FRENETTE GARDENS

SB# 03-22 CU #05-22

STAFF REPORT #2

June 22, 2022

DATE: APRIL 20, 2022 SCALE: 1" = 60'
PROJECT NO: 21-0928-1 SHEET 1 OF 16

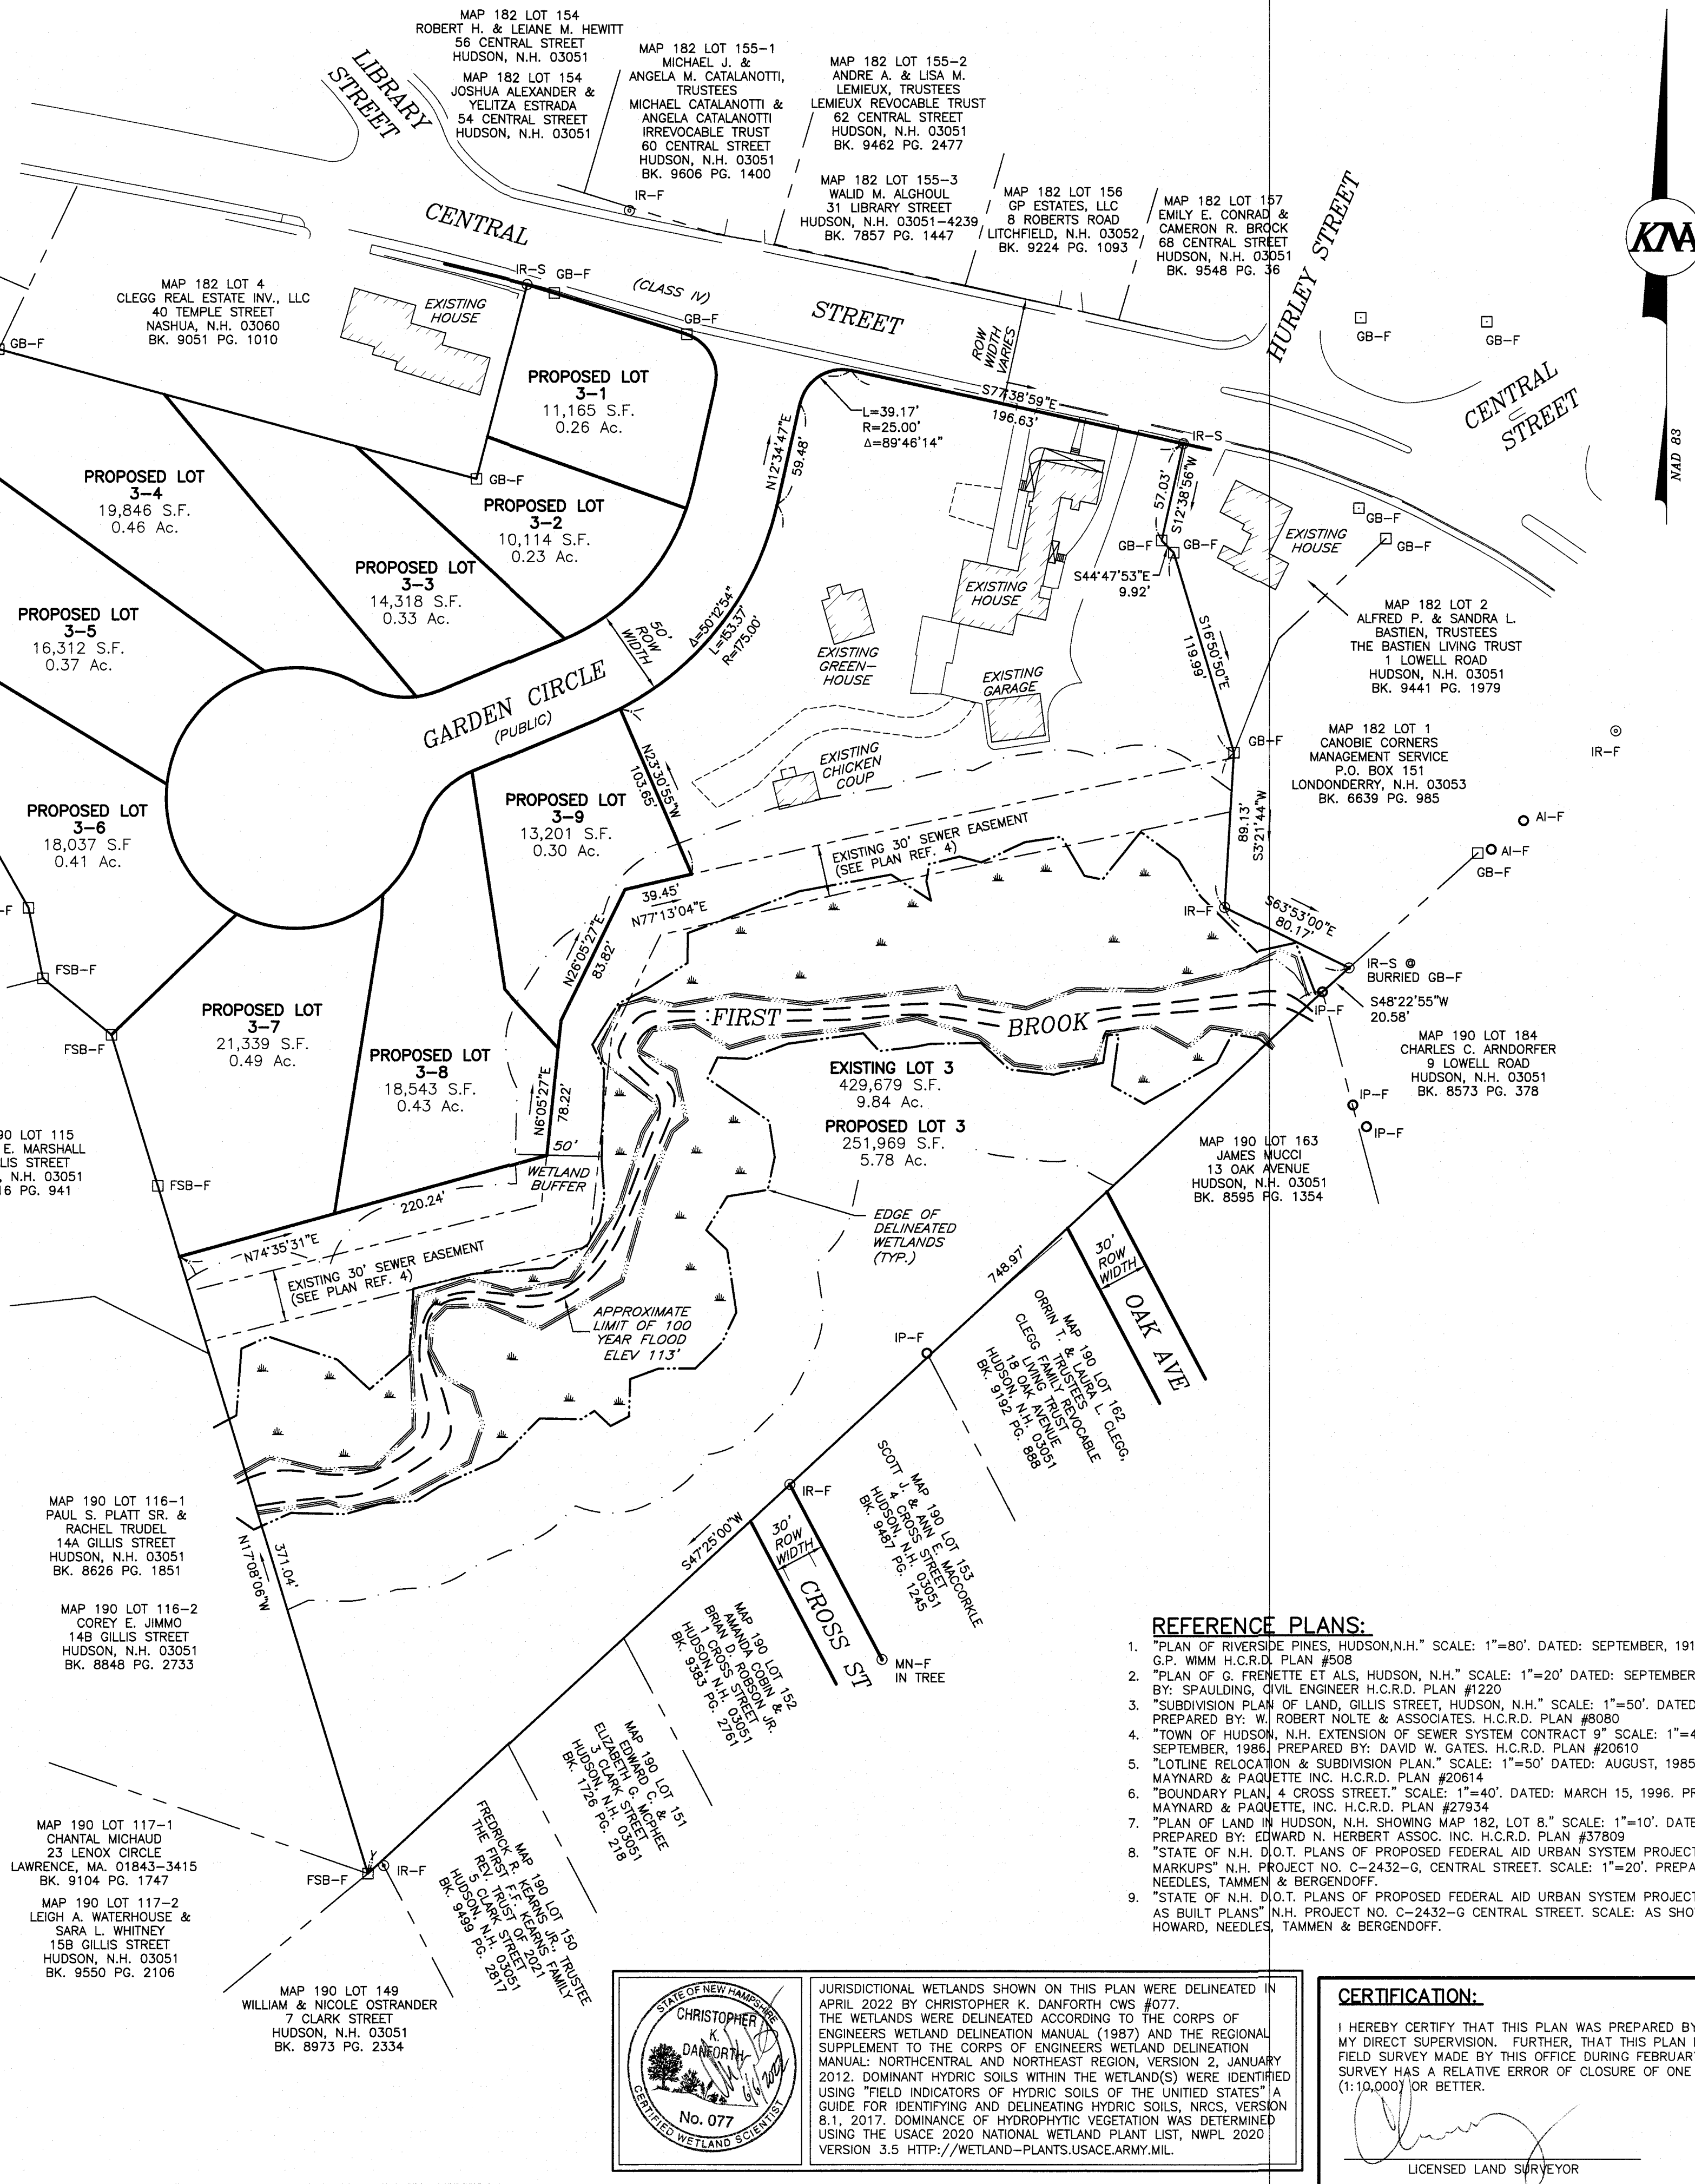
- h. HR 276-11.1.B.(20). The applicant has not noted existing building heights on the plan set.

- a. HR 334-14 and HR 276-11.1.B.(20). The applicant has not noted the maximum proposed building heights on the plan set. The applicant should note the maximum building height of 38 feet on the plan set.

- b. HR 334-20. The site is located in the Town Residence (TR) District. The applicant should provide a formal use note confirming that single family homes are the proposed use.

- b. HR 290-10.B. The applicant has noted the need for a NPDES Notice of Intent. The applicant should expand this to also note the need for a SWPPP on the plan set.

The highest building on site is the existing barn which, at its peak, is approximately 38 feet high. Please see Note #3 on Sheet 1.

Information regarding granite bounds can be found on Note #12 on Sheet 1.

As the plan is a conventional subdivision plan, it does not propose the construction of any buildings. Regardless, the maximum building height of 38 feet has been added to Note #3 on Sheet 1.

Please see Note #21 on Sheet 1.

Note #16 on Sheet 1 has been expanded accordingly.

DATE: APRIL 20, 2022 SCALE: 1" = 30'
 PROJECT NO: 21-0928-1 SHEET 5 OF 16

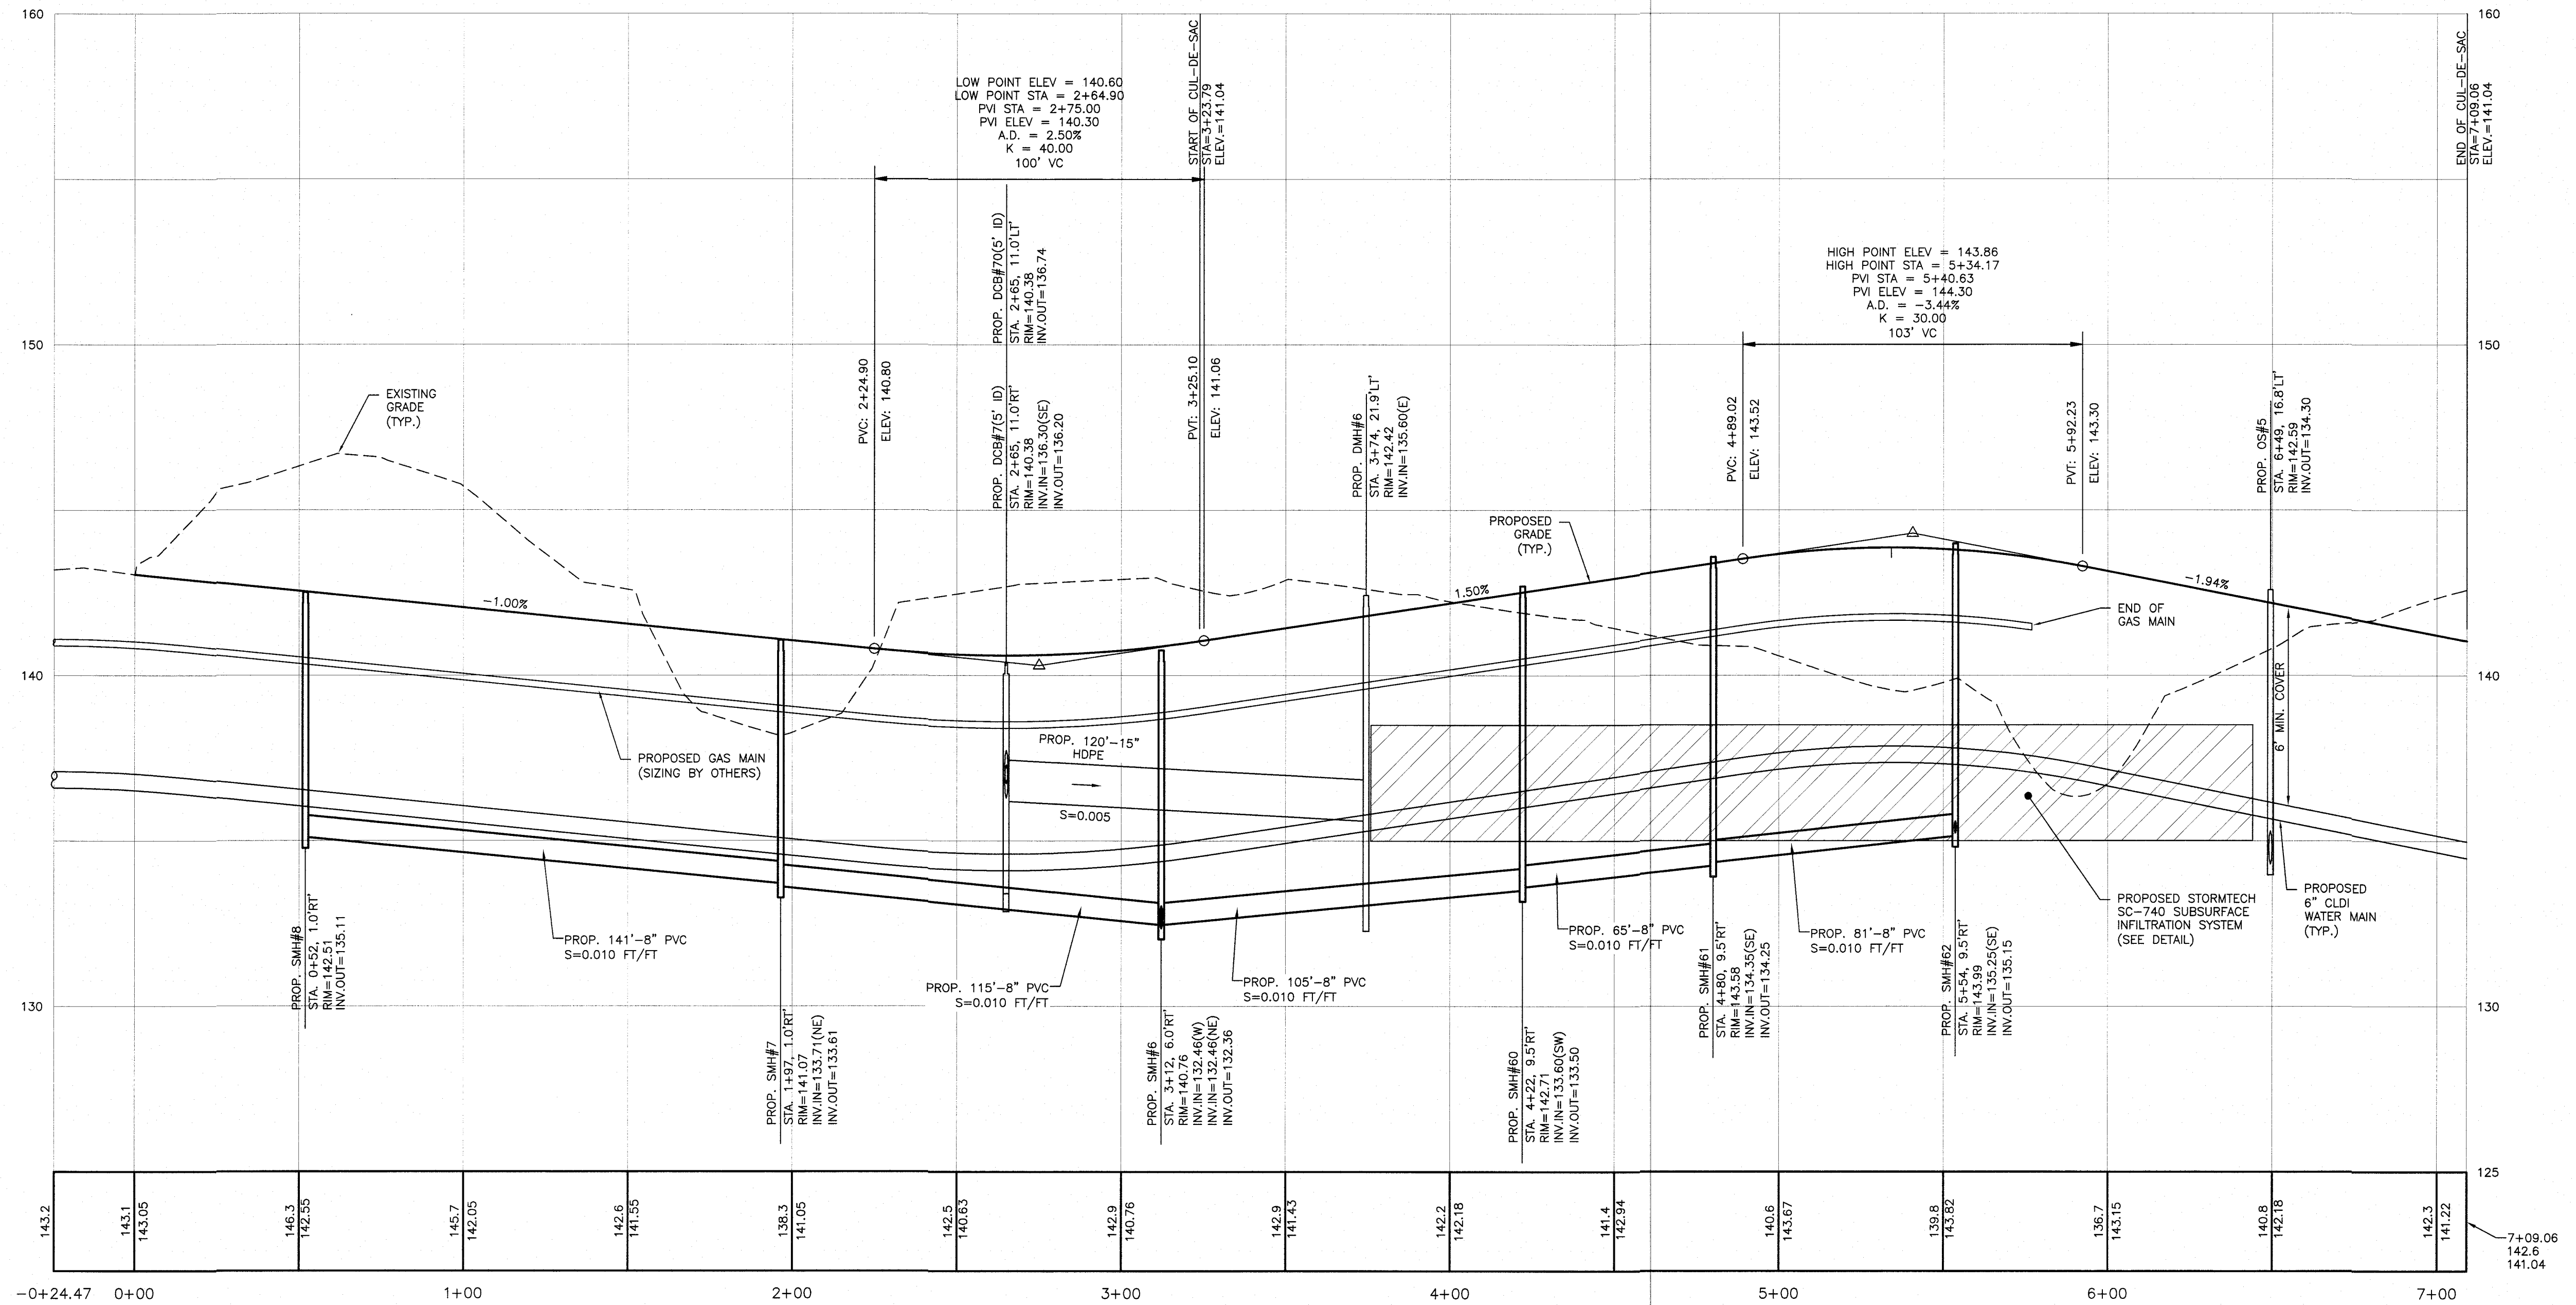
- b. HR 289-18.B.(5). The applicant should add a dead-end informational sign to the plan set and a detail for the sign.

- a. The applicant has shown a lot of design elements on the Roadway Plan. There are locations where lines and symbols are overwritten by other notes. We recommend that the applicant review the plan to more clearly show the information for ease of use by the construction contractor.

- b. ETGTD Section 565.1.1. The applicant is reminded that the Town of Hudson has specific requirements for the importing of off-site fill materials for use in constructing this project. We recommended that these requirements be stated on the plans for the Contractors attention.

The cul-de-sac curb radius has been increased to 65 feet to meet the requirement. Additionally, the alignment and edge of pavement have been revised accordingly (see Sheet 5).

A dead-end sign and detail have been added to the plan set (see Sheets 5 & 11).

The plan has been revised to remove as many overlaps as possible.

Please see the additional notes on Sheet 5 stating the town requirements for importing off-site materials.

DATE: APRIL 20, 2022 SCALE: 1" = 30'
 PROJECT NO: 21-0928-1 SHEET 7 OF 16

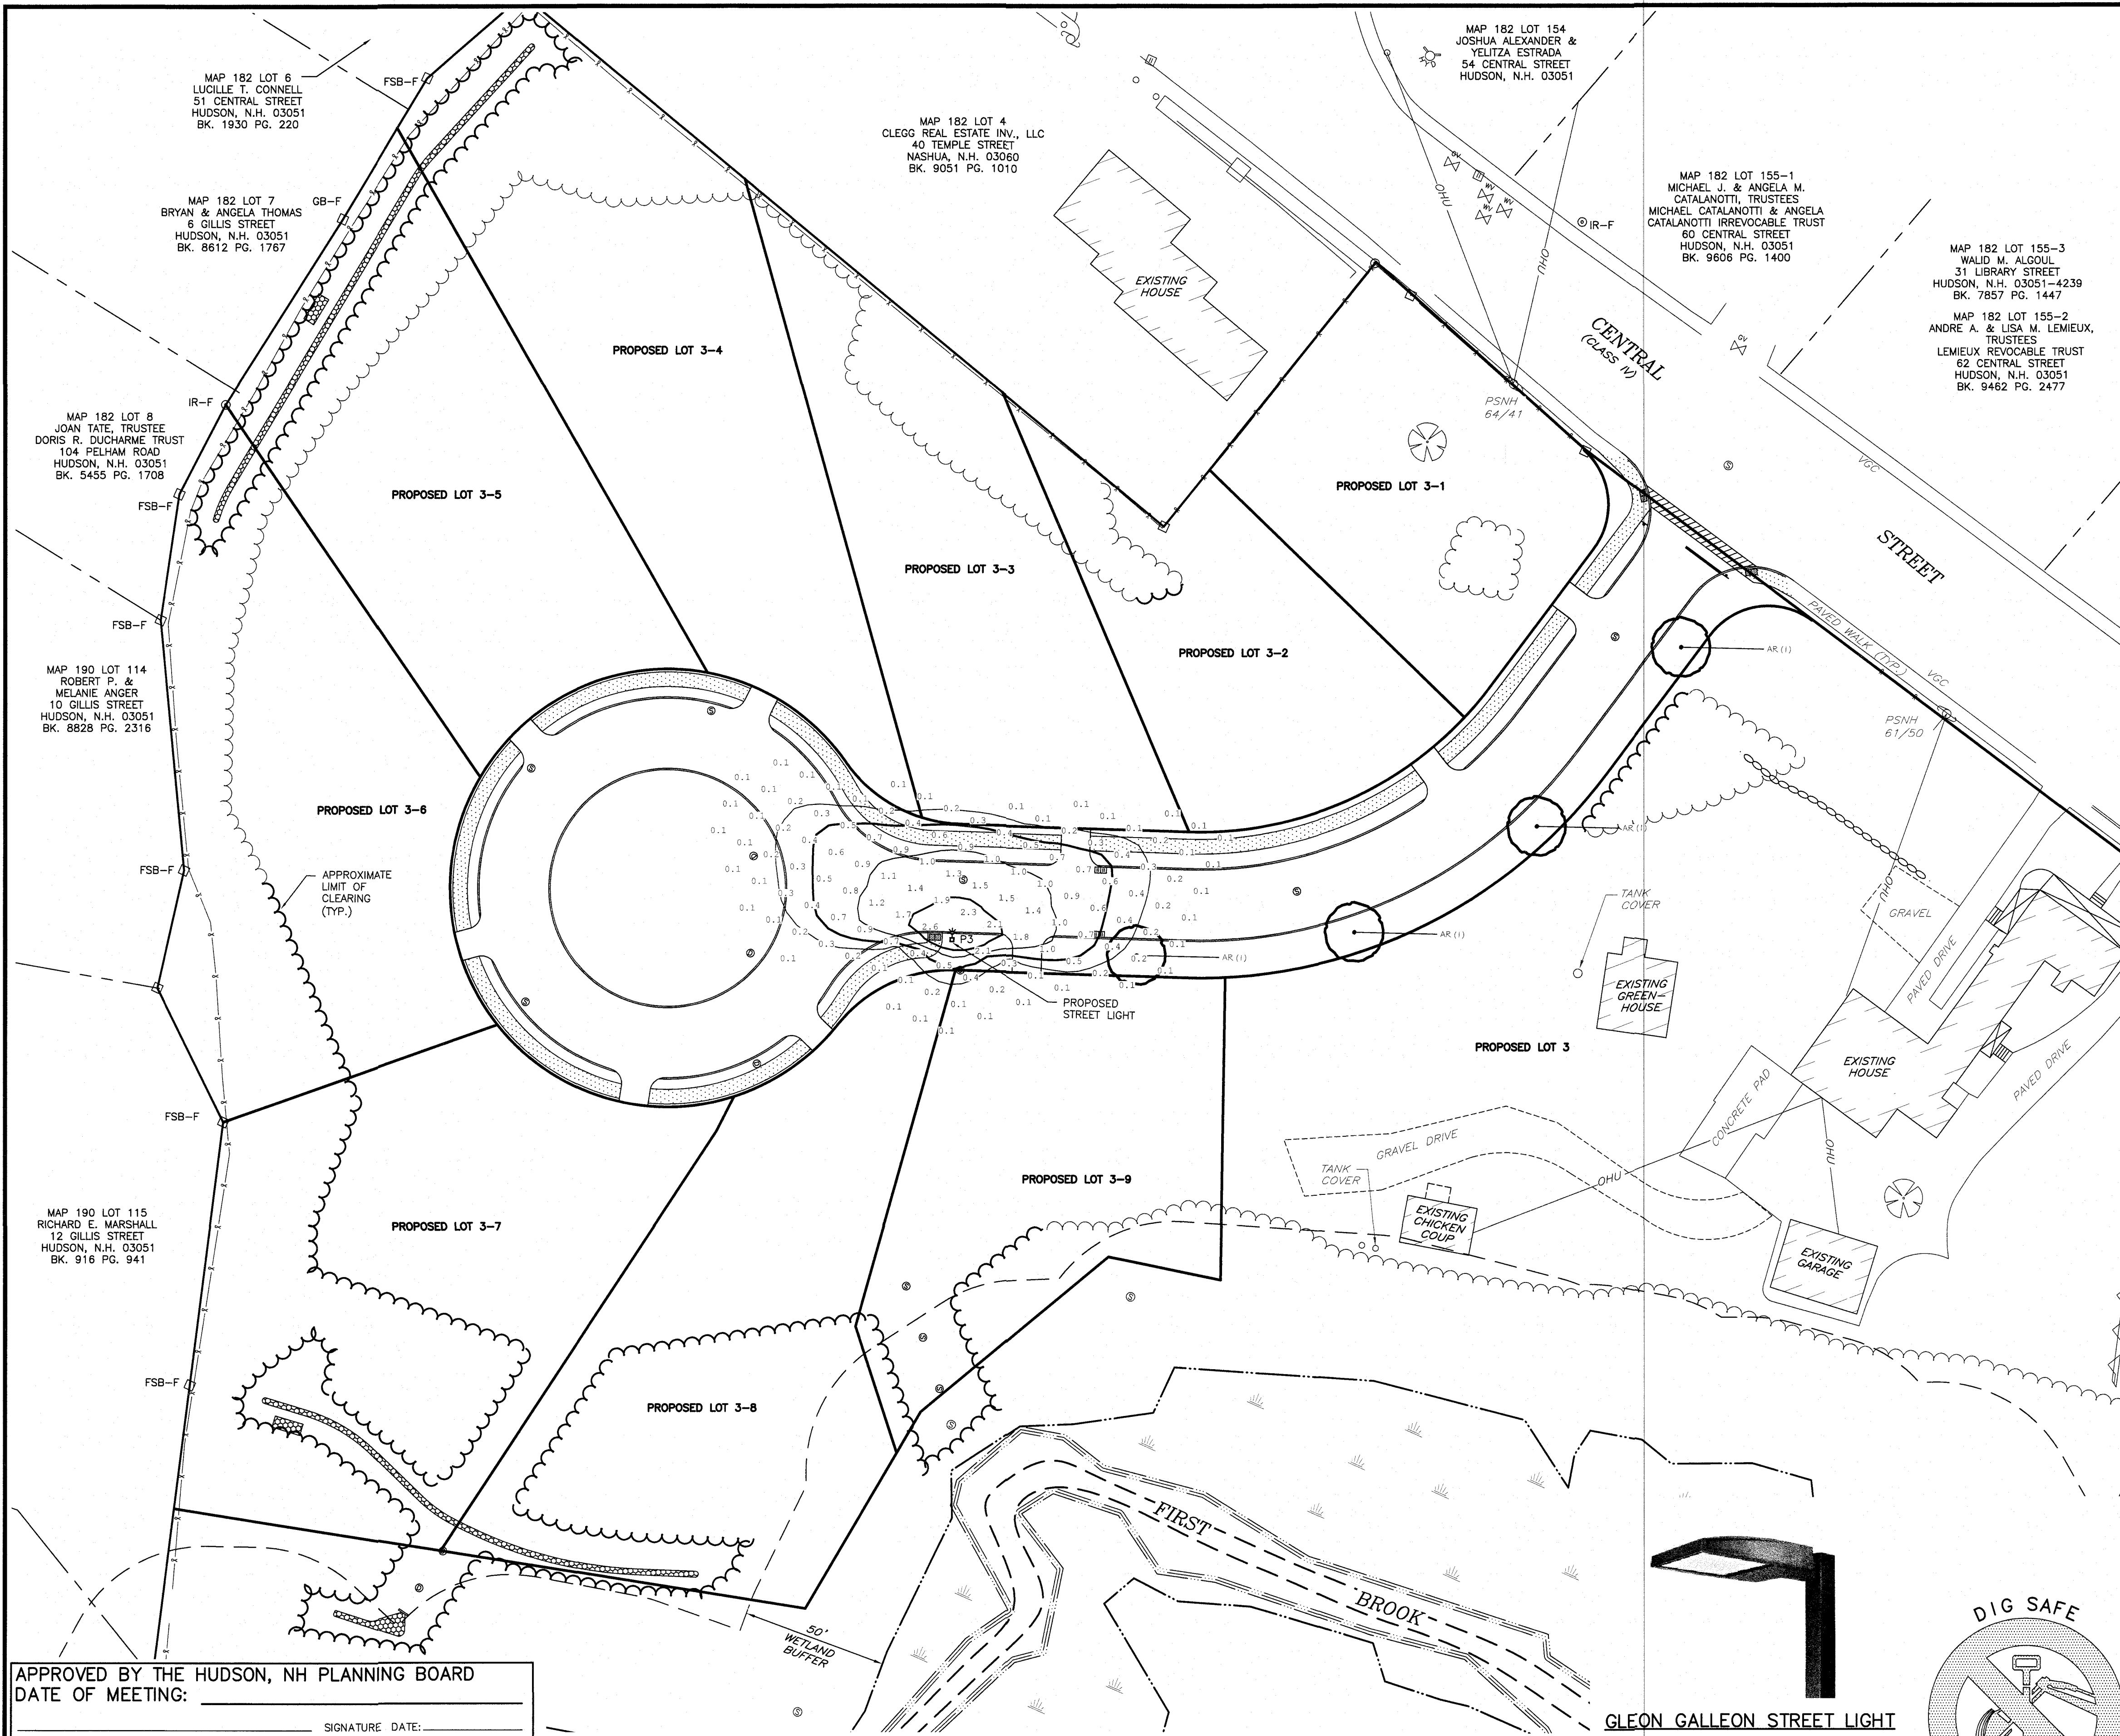
- a. HR 290-5.A.10. Due to the close proximity of the onsite wetlands, and as to avoid unwanted additional wetland impacts, we recommend that the applicant add a note stating that orange construction fence will be placed at all wetland buffers within 50-feet of proposed grading. This fence is recommended during build out, and kept up until the site is complete.

Note #11 has been added to Sheet 7 reflecting this recommendation.
